# Re: EB-2023-0037 - London Hydro Inc. IRM Application for 2024 Distribution Rates

# OEB Staff Interrogatories London Hydro Inc. EB-2023-0037

#### Ref: LH\_Attachment\_E\_2024-IRM-Rate-Generator-Model\_Updated\_20240109\_20240124.xls

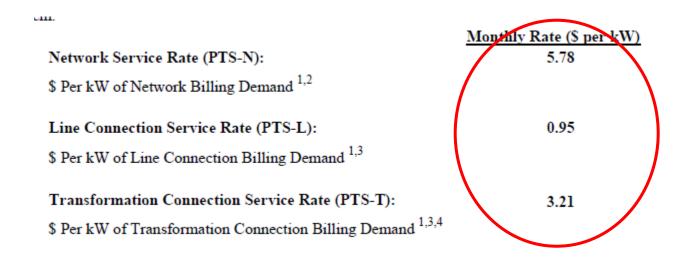
The decision led to an increase of \$0.02 per kW for the Network Service Rate.

OEB staff has updated the LDC's rate generator with the final UTRs as follows:

1) Please confirm the accuracy of the Rate Generator update in the reference.
